**Preliminary Subdivision & Site Plan Application Additional Materials: Highland Views
Manufactured Housing Park & Mixed Use Development**

Subject: Comment Response – Highland Views

In response to the recent review provided by Jonathan R. Earle, Town Engineer for Windham, regarding the geology and stormwater review of the Highland Views project, we would like to offer the following responses:

DATE:	12/5/2016
SCALE:	1"=40'
DESIGNED:	JDA
JOB NO:	1636
FILE: 1636 S	
SHEET	C-8.0

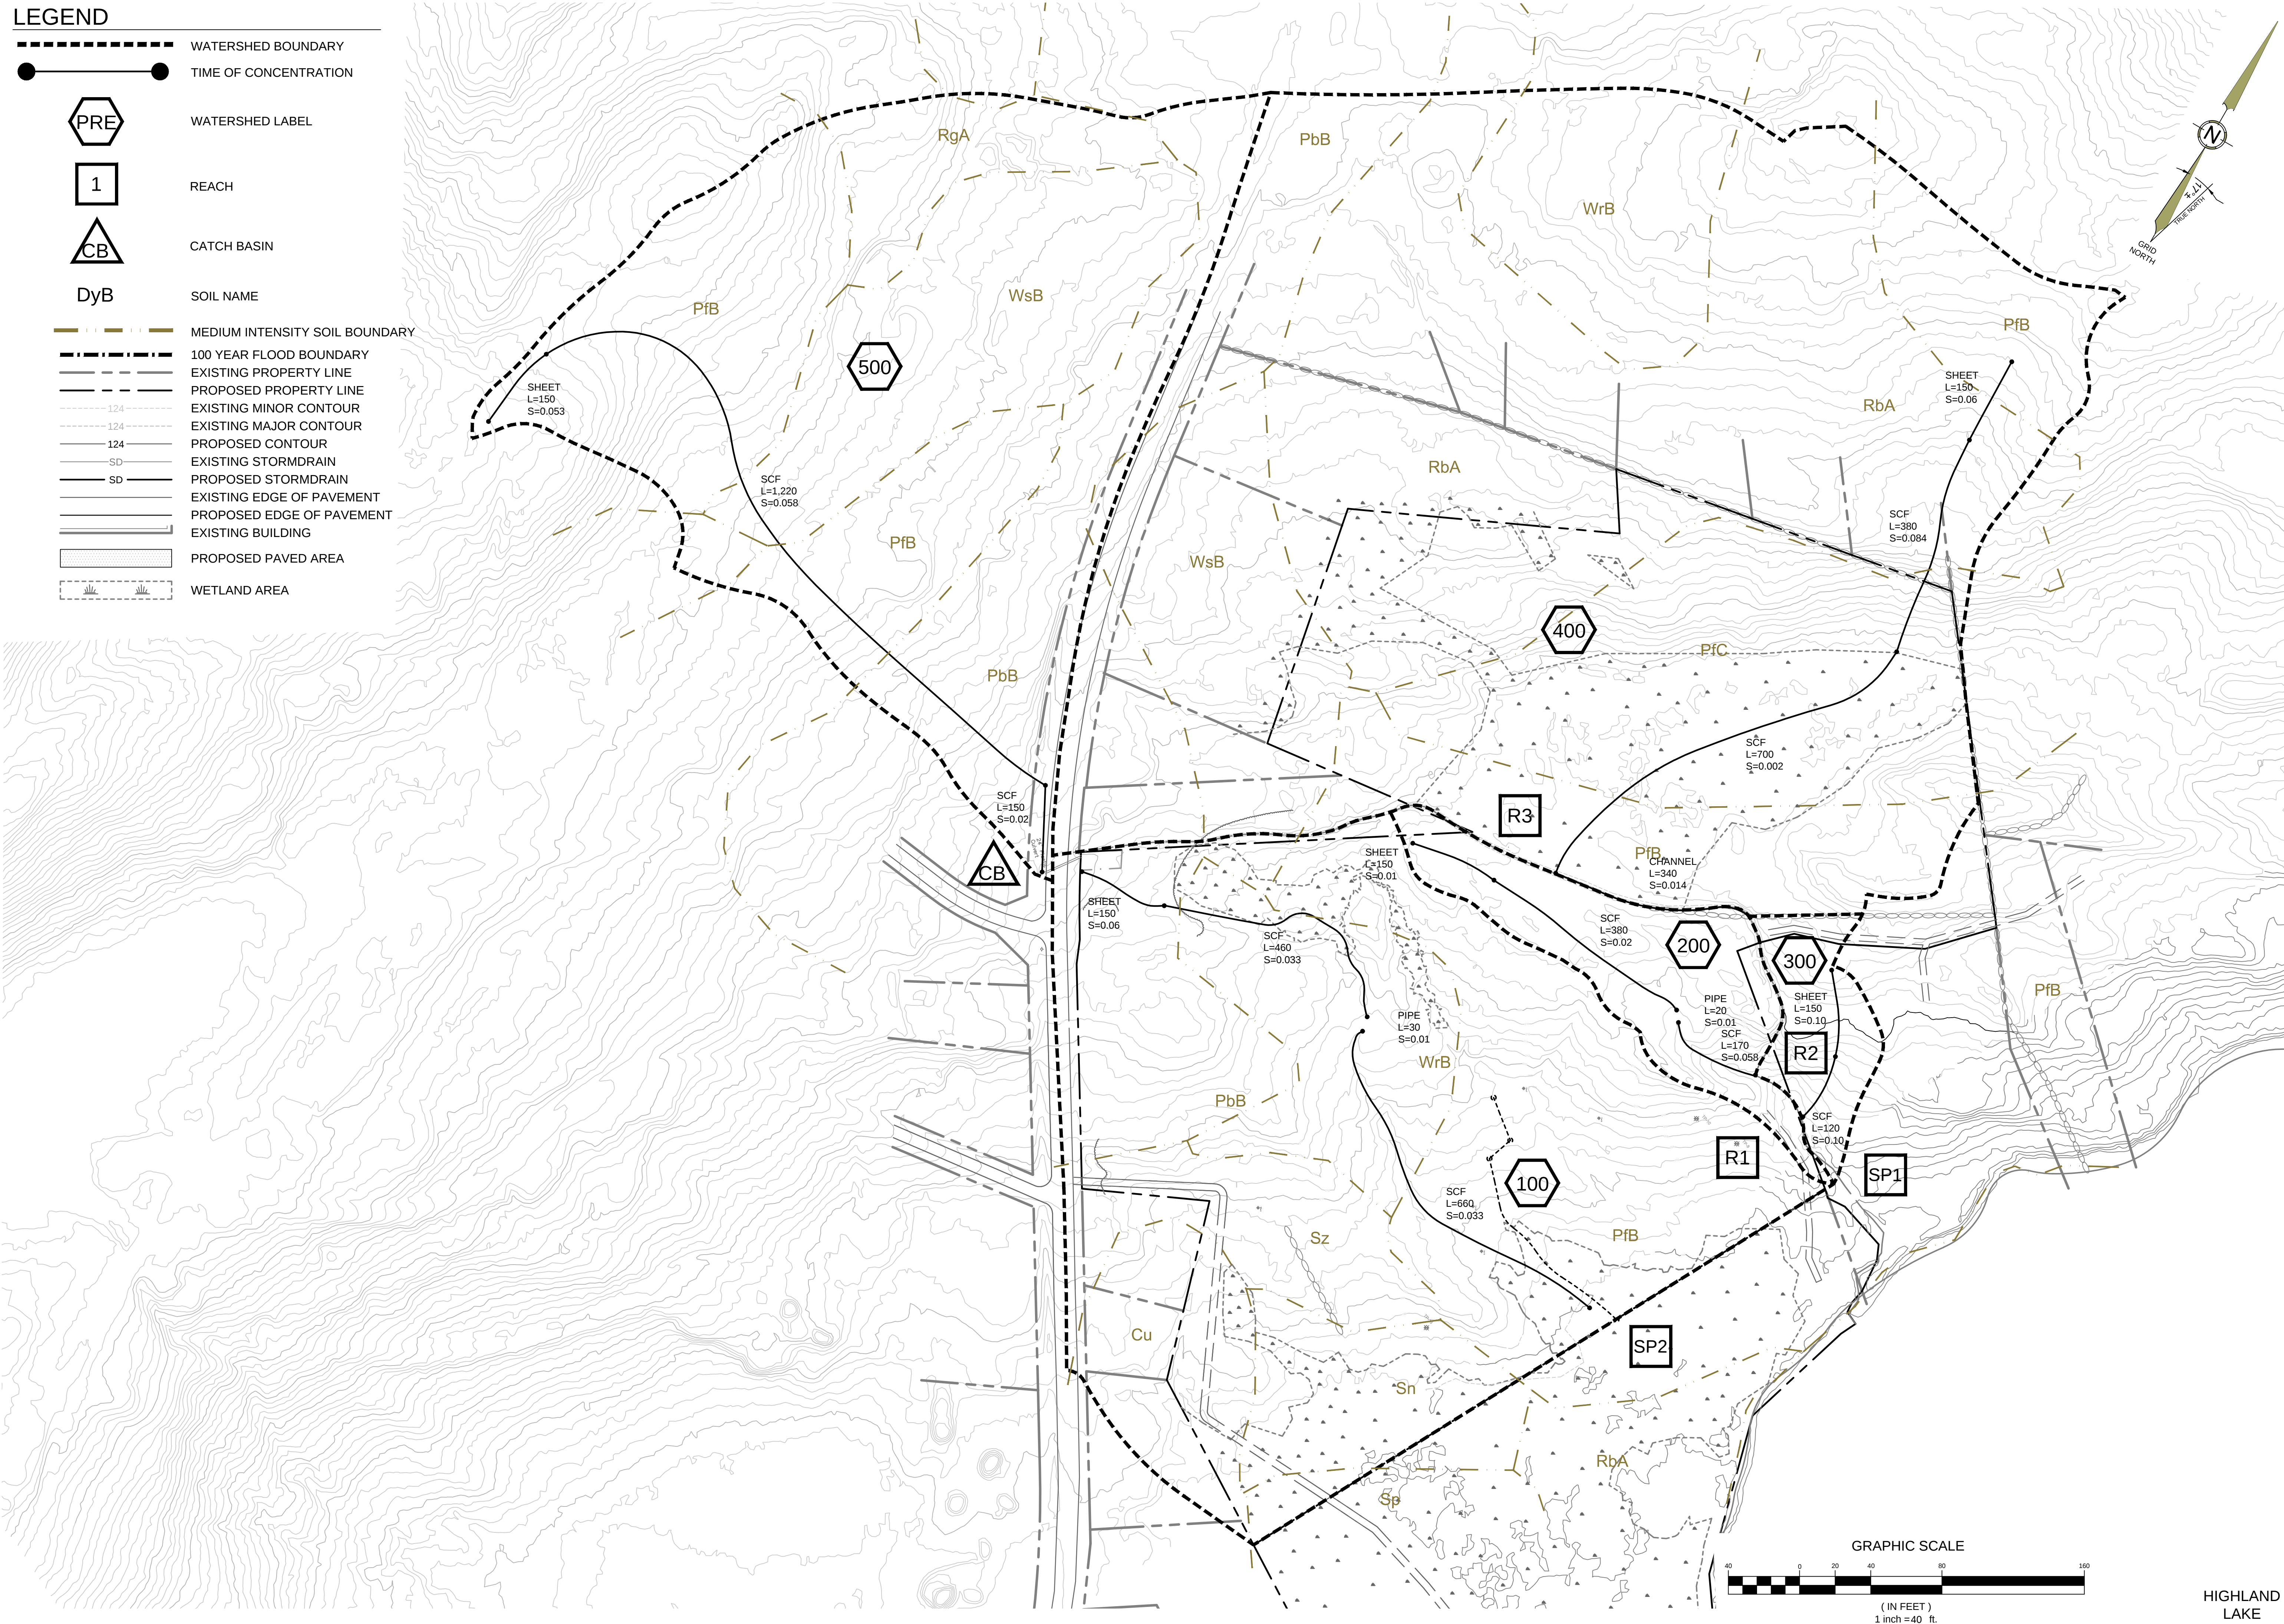
6. Predevelopment stormwater plan & calculations – On sheet C8.0, there is a time of concentration segment at the end of the flow path calling out 150' of shallow concentrated flow that's not show in the modelling. Please clarify.

SHEET
C-8.1

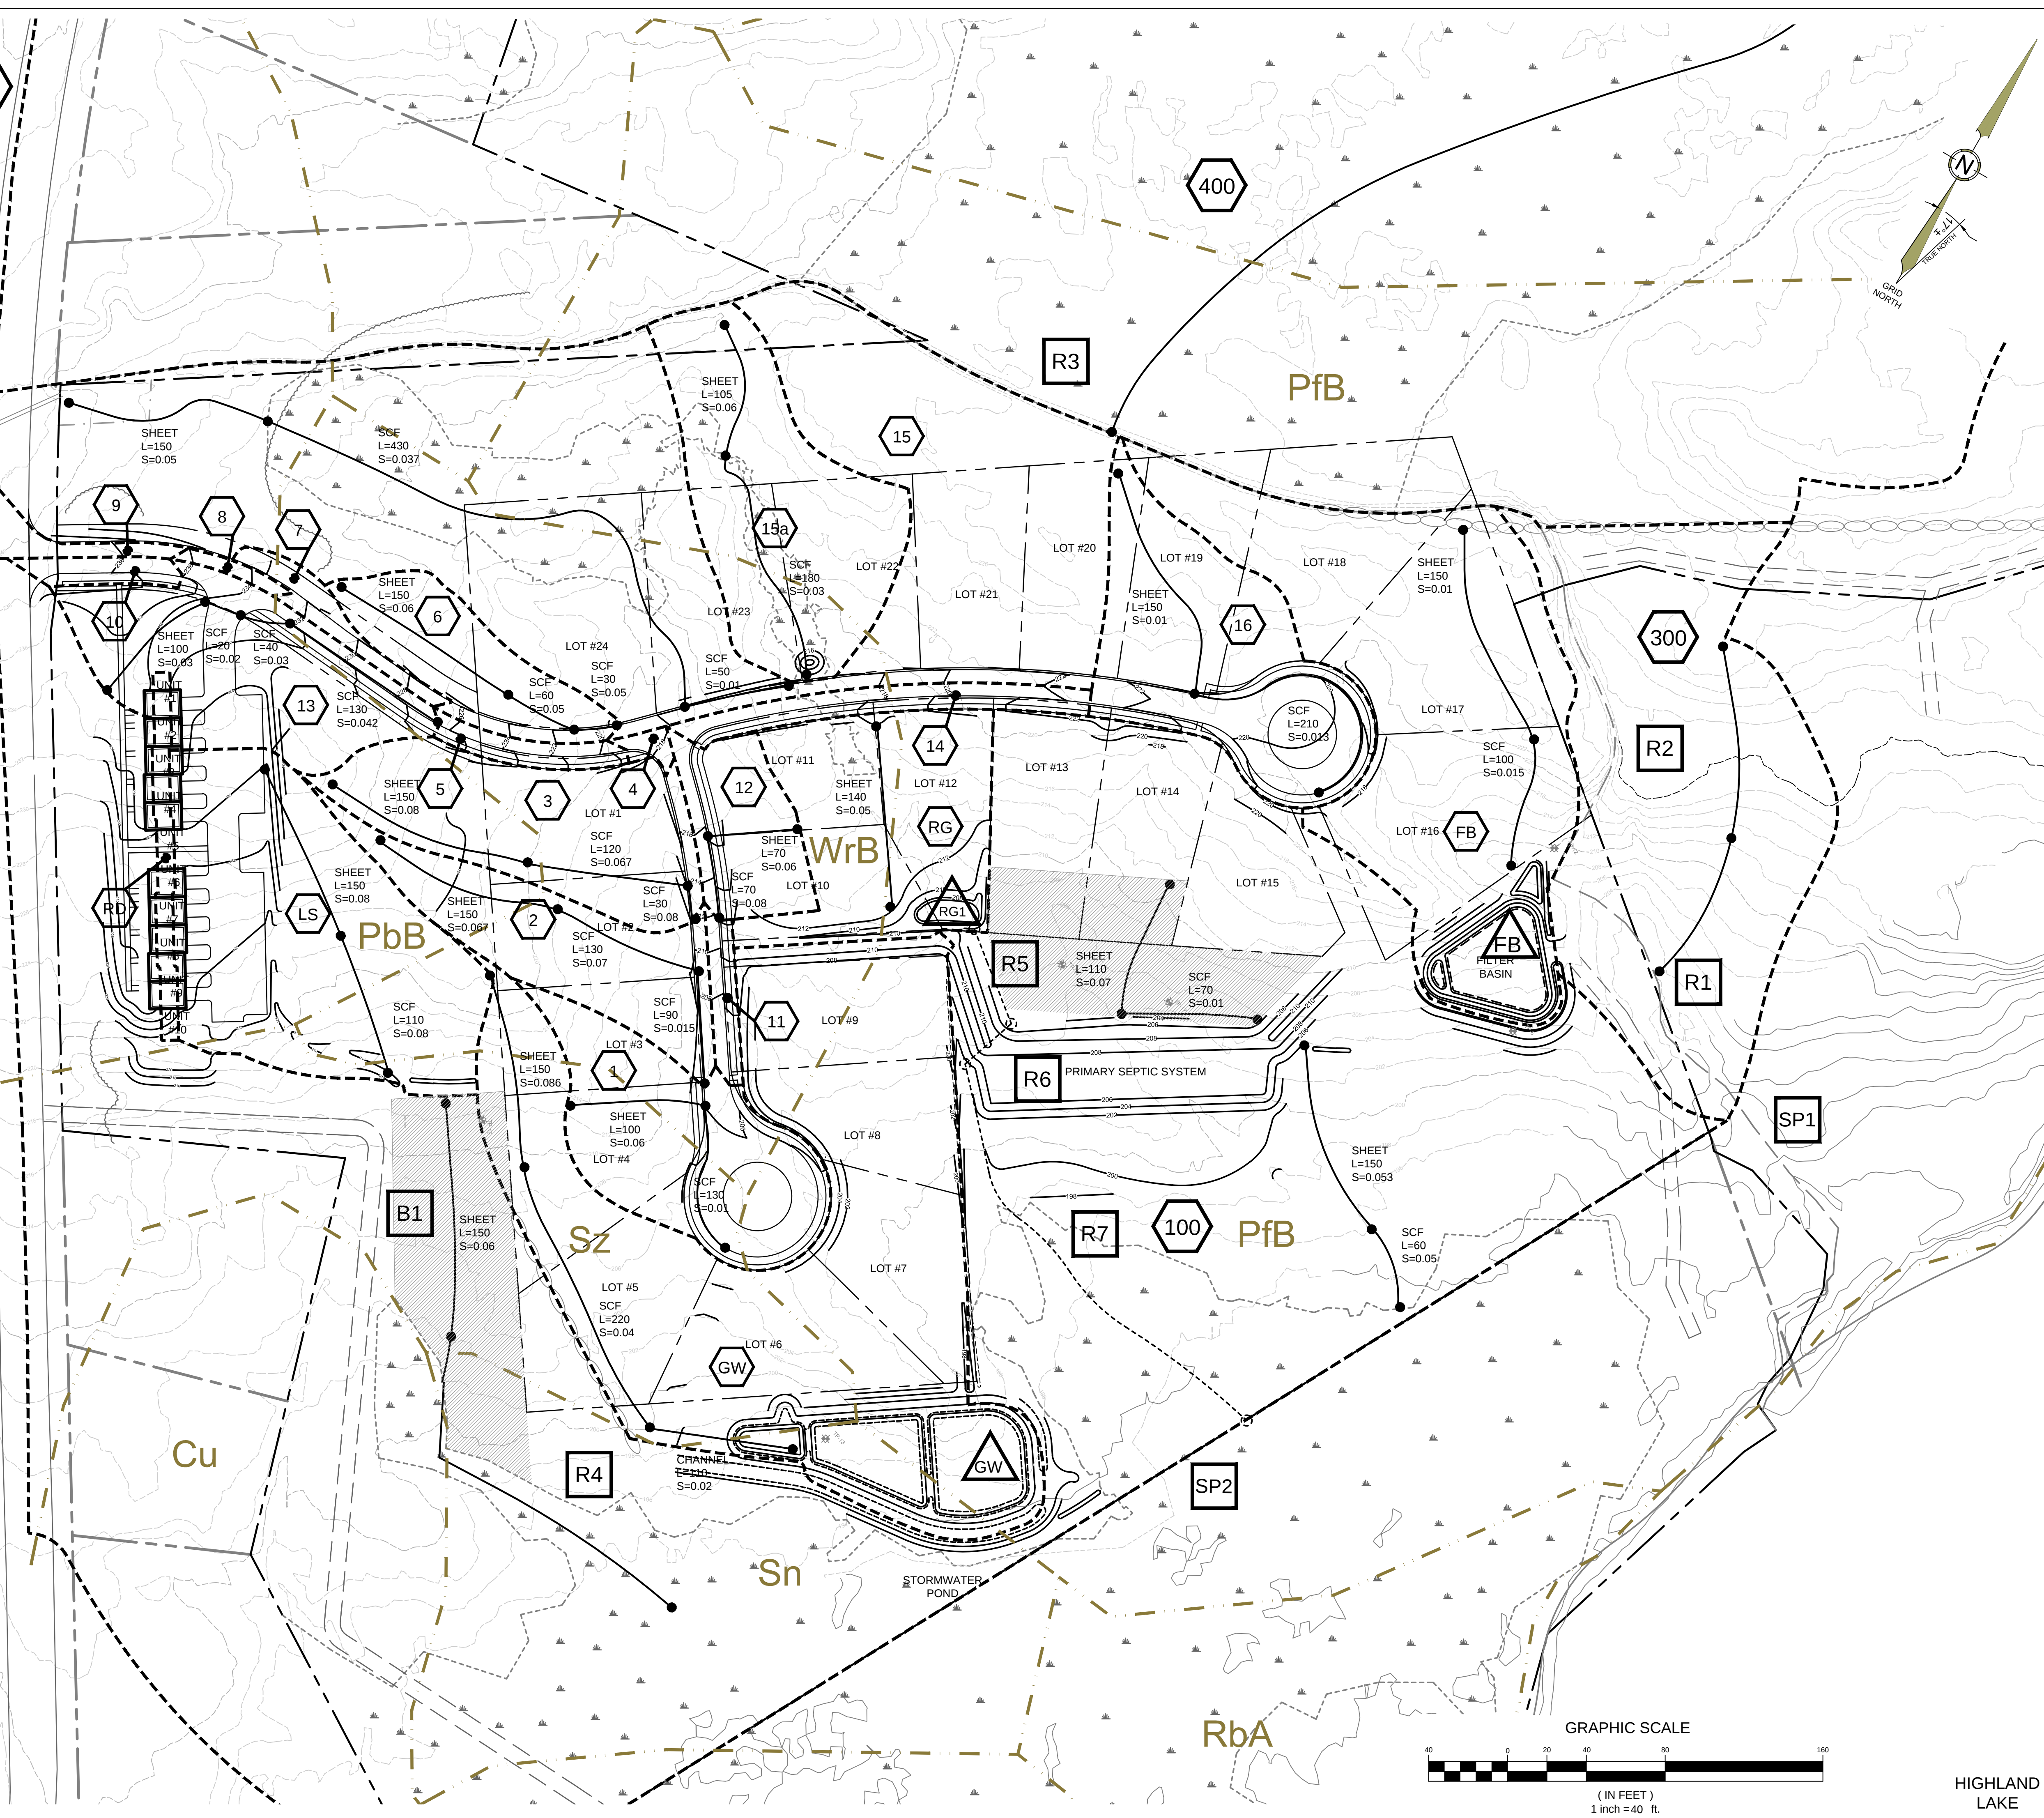
2. Reference the installation of roof dripline filter beds on sheet C8.1. The filter beds are called out on the signature/approval plan, but noting this on the post-development watershed plan would provide additional clarification.

4. The level spreader on sheet C8.1 scales to 20' but is called out as 30' on the grading plan. Please clarify.

We've added the entire Stormwater Restrictions note from the subdivision plan to Sheet C8.1.

The forested buffers are now labeled on C8.1. I've also added the buffer hatching to the sheet legend.
